Service Letter ACSL-SOTEN-SB24-018

ACSL TAKEOFF for SOTEN

Version 1.16.0 Release Notes

Figure 1. ACSL TAKEOFF ground control application "System Information" tab.
*Note that "Falcon 1.0.9" may be displayed without any change in functionality.

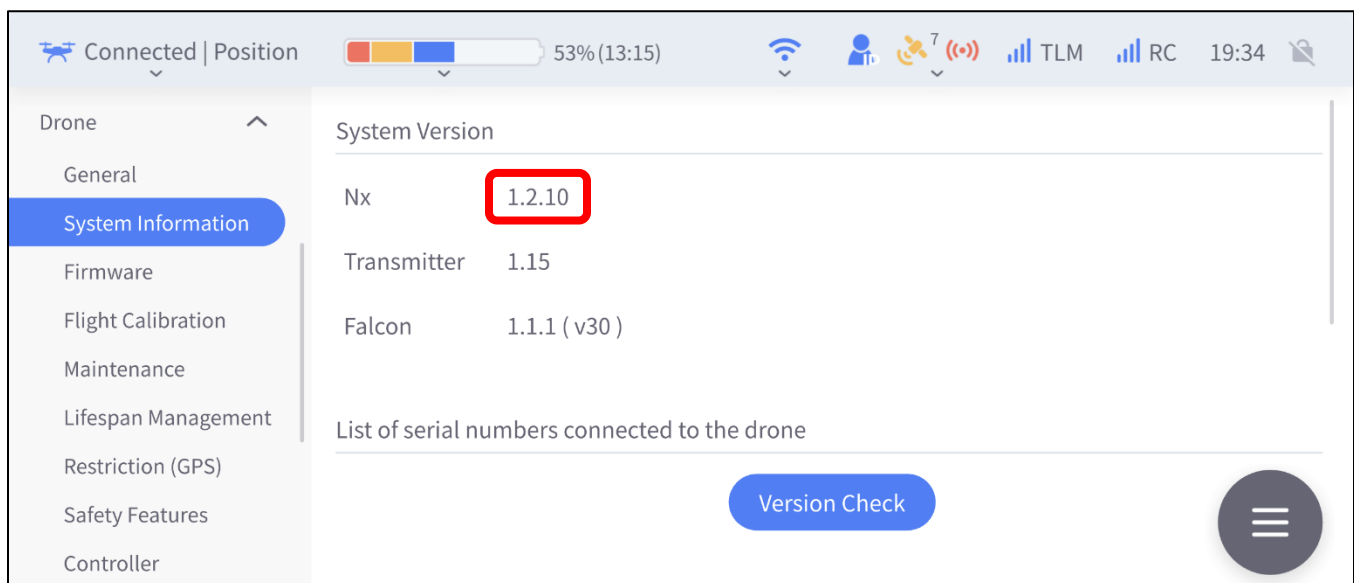
The ACSL TAKEOFF for SOTEN ground control application version 1.16.0 includes SOTEN aircraft (Nx) firmware version 1.2.10, CX-GB100, CX-GB300, and CX-GB400 camera firmware version 1.20, and CX-GB200 camera firmware version 1.21. When the SOTEN aircraft is successfully updated, the "System Information" tab in the "Settings" view of the TAKEOFF application should indicate "Nx 1.2.10" as shown in Figure 1.

Figure 2. The Restrictions (GPS) default settings.

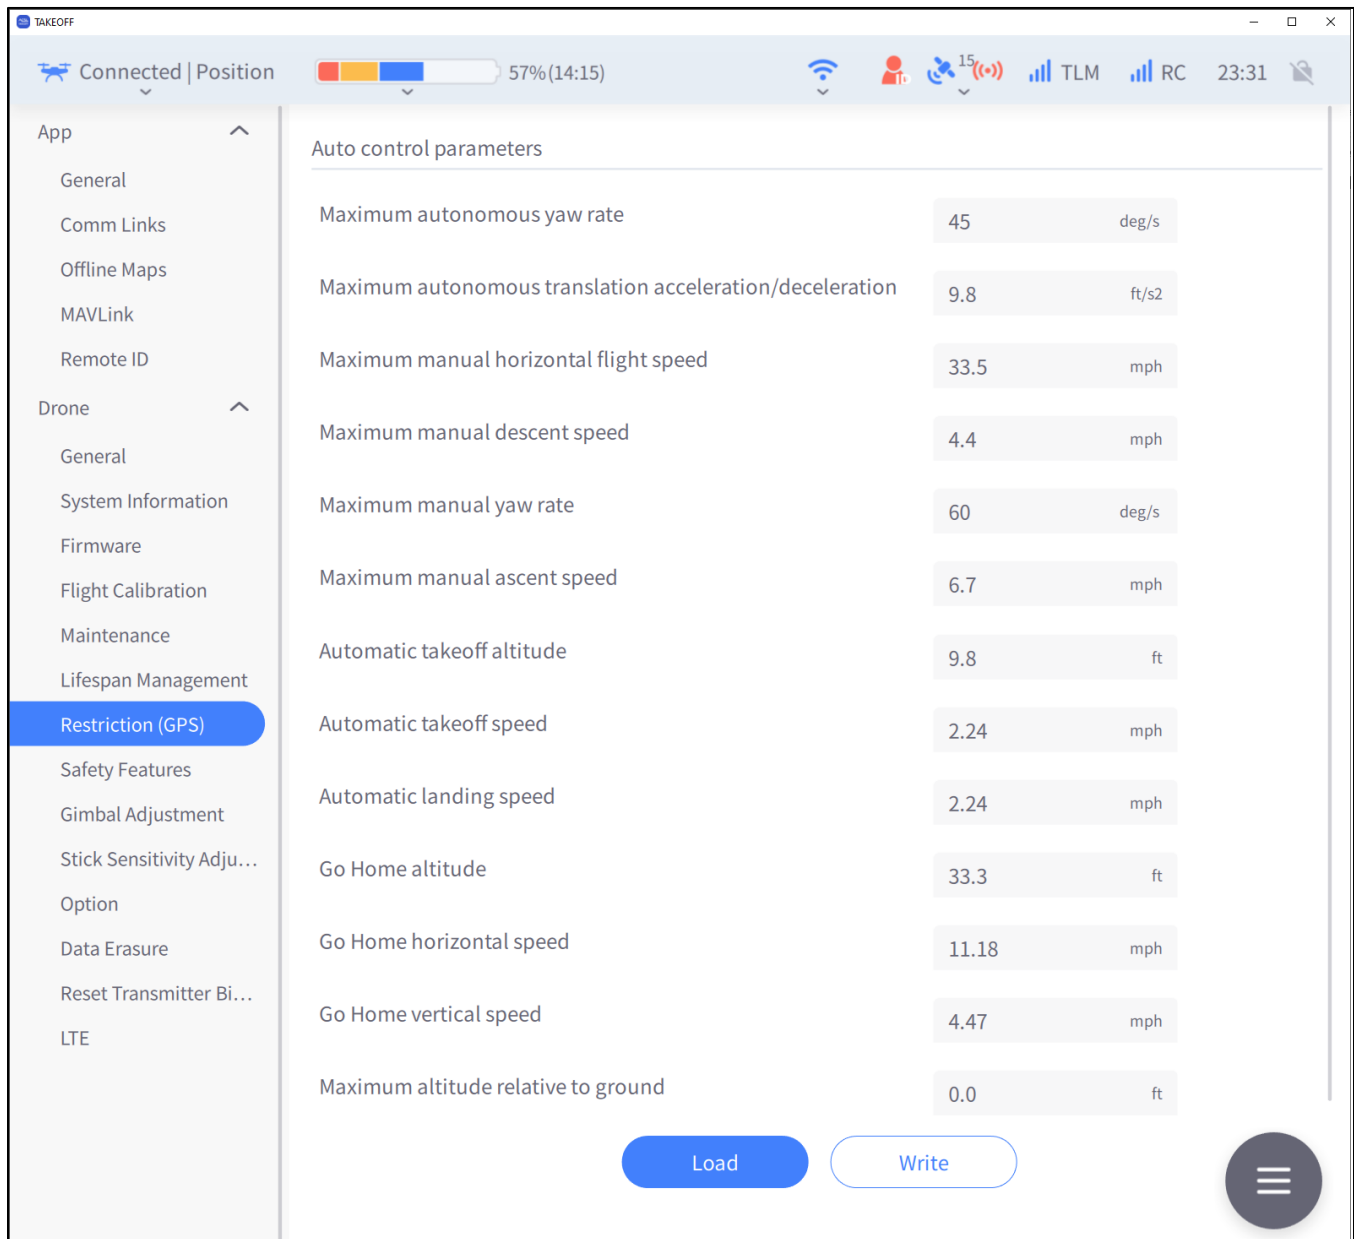
When the SOTEN aircraft is updated with the firmware that is included with this version of TAKEOFF **some of the aircraft settings will be automatically reset to their default values**. Any previous changes to those aircraft settings will not be retained. If you wish to keep the current settings, make a record of the settings prior to the update and reenter those settings after the update. The settings that will be reset are summarized in the screenshots below.

- Restrictions (GPS) settings will reset those shown in Figure 2.

Figure 3. The Safety Features default settings.

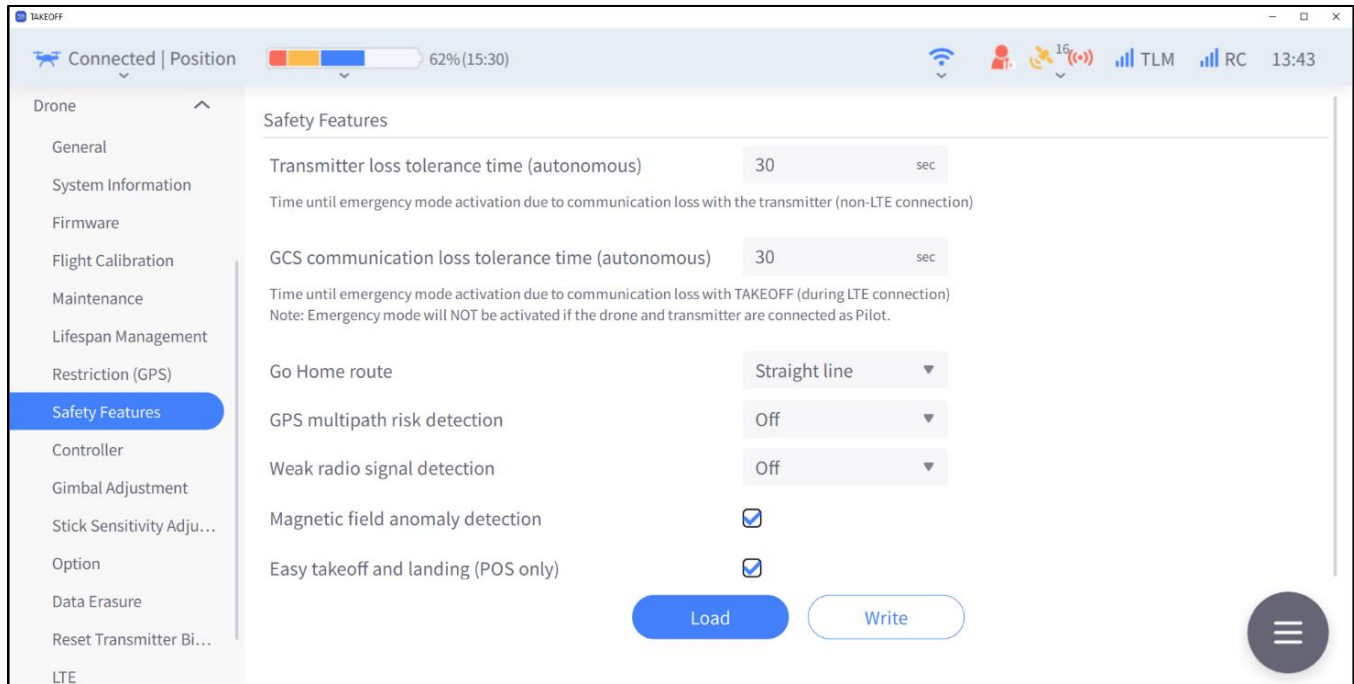
- The Safety Features settings will reset to those shown in Figure 3.

Figure 4. The Gimbal Adjustment default settings.

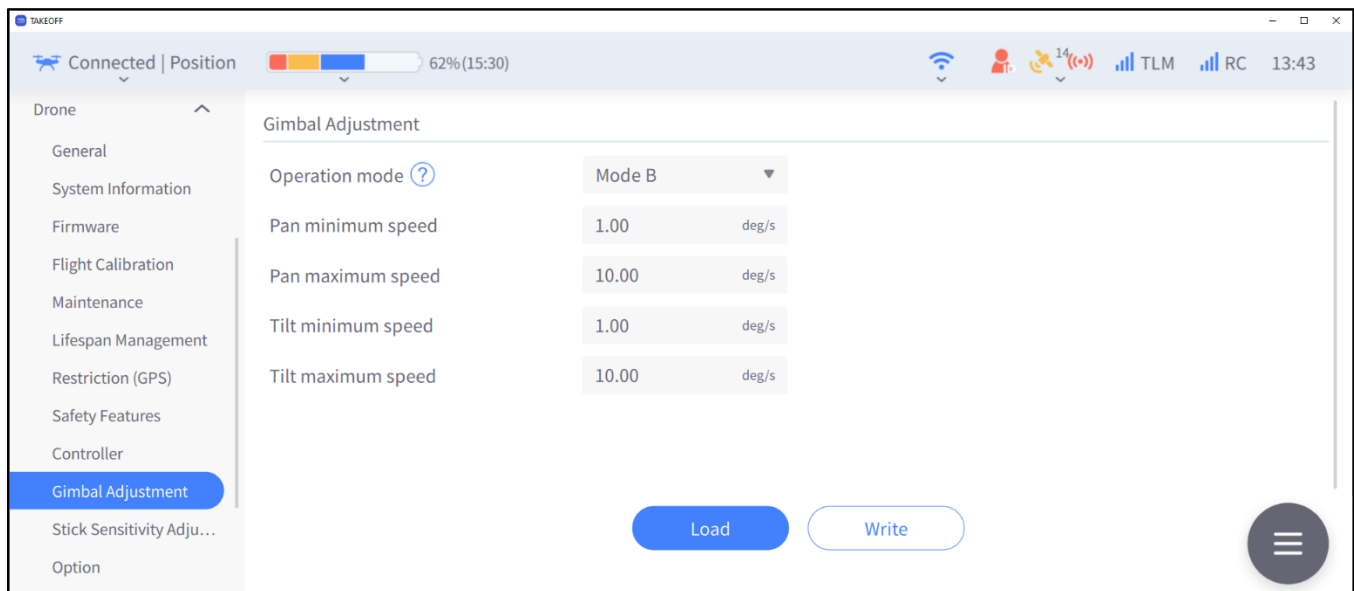
- The Gimbal Adjustment settings will reset to those shown in Figure 4.

Figure 5. The Stick Sensitivity default settings

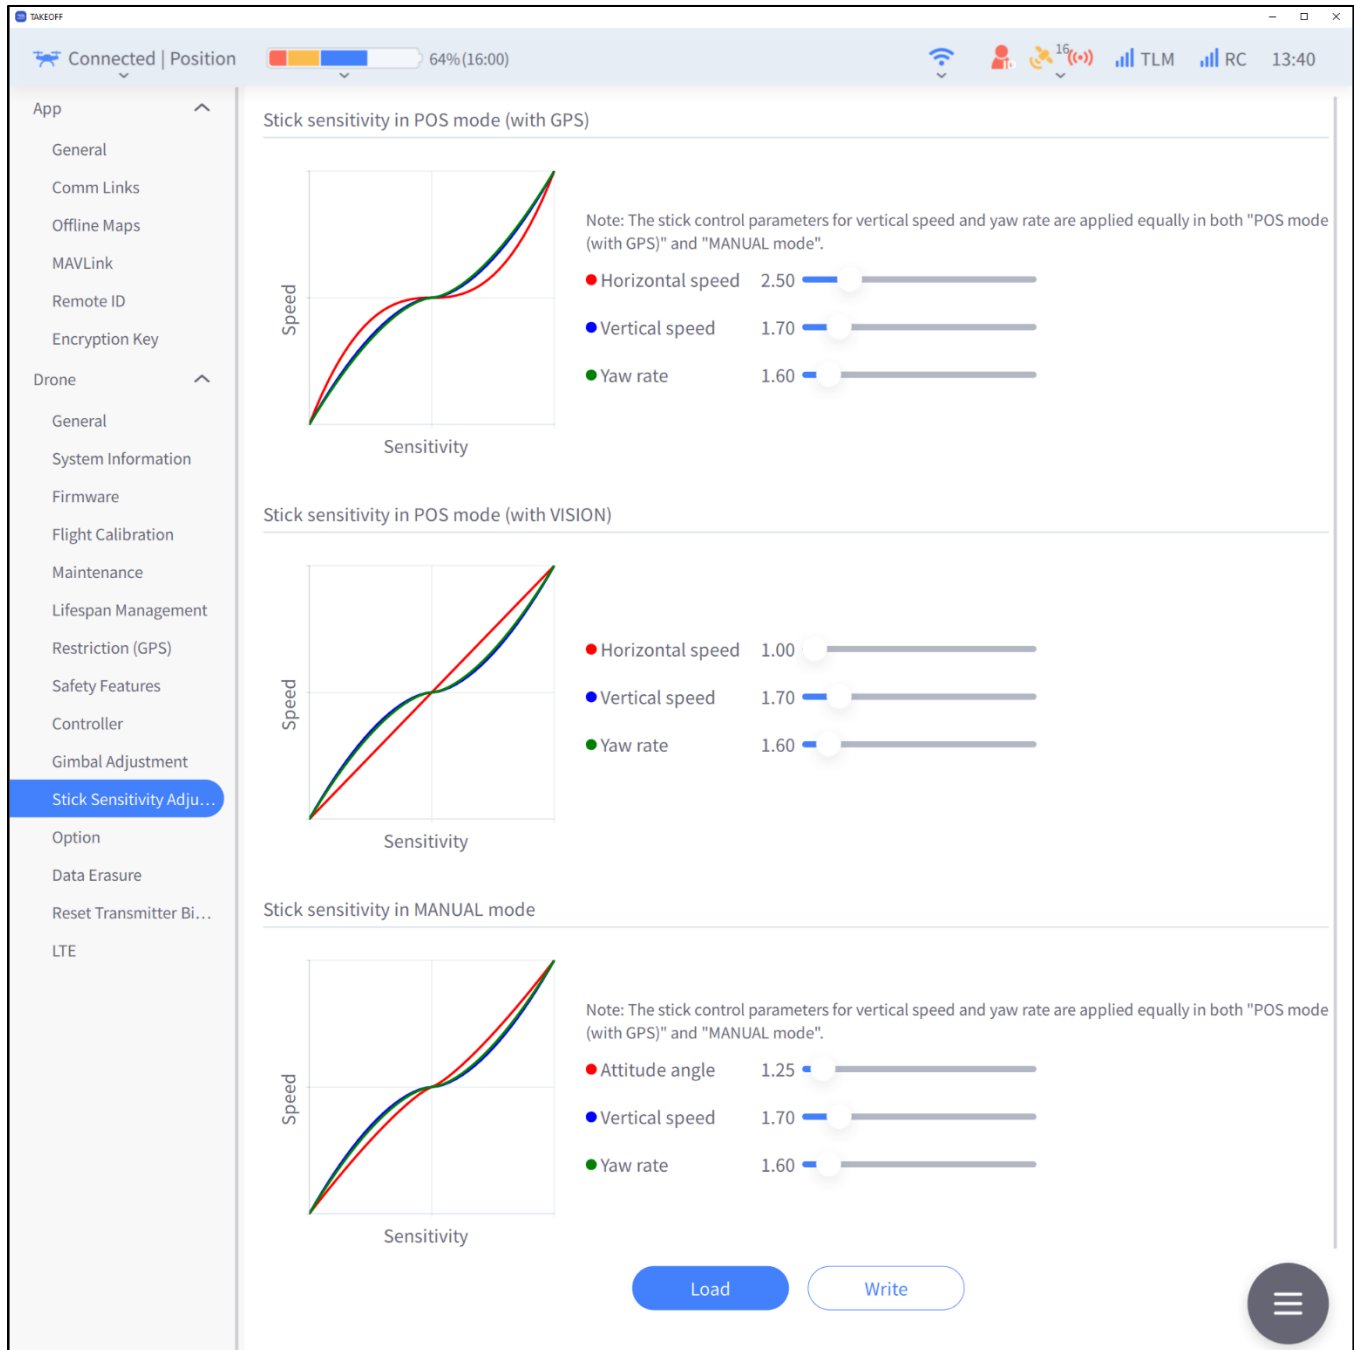
- The Stick Sensitivity settings will reset to those shown in Figure 5.

Figure 6. The Option default settings.

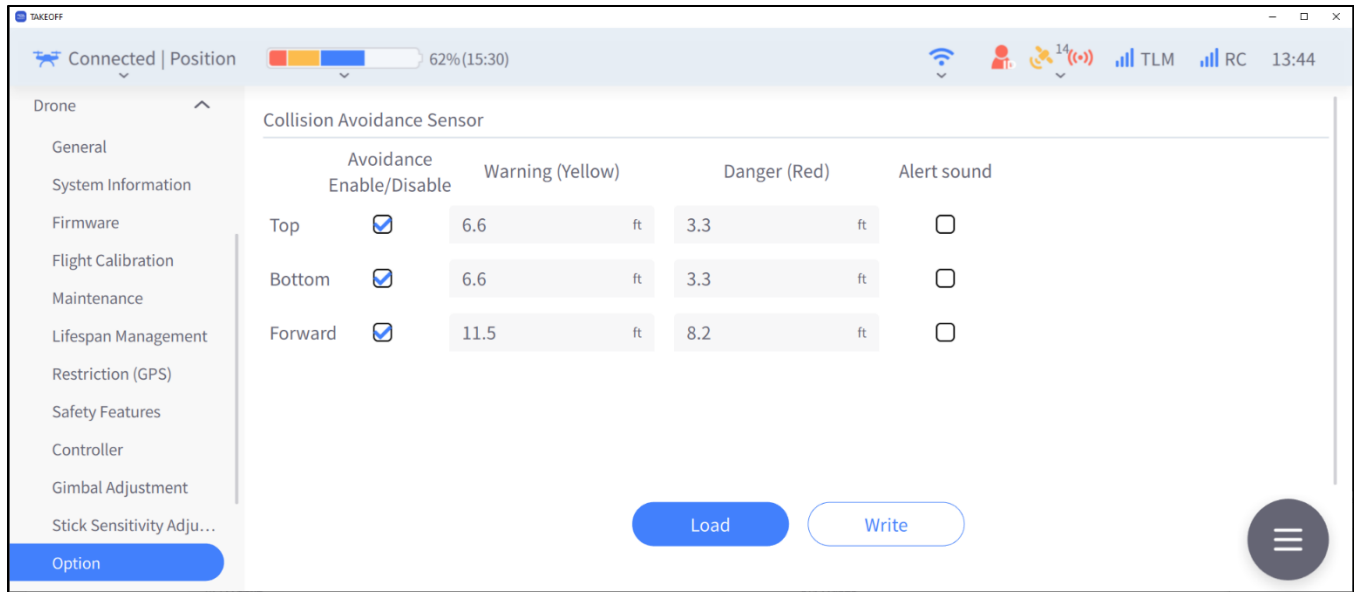
- The Option settings will reset to those shown in Figure 6.
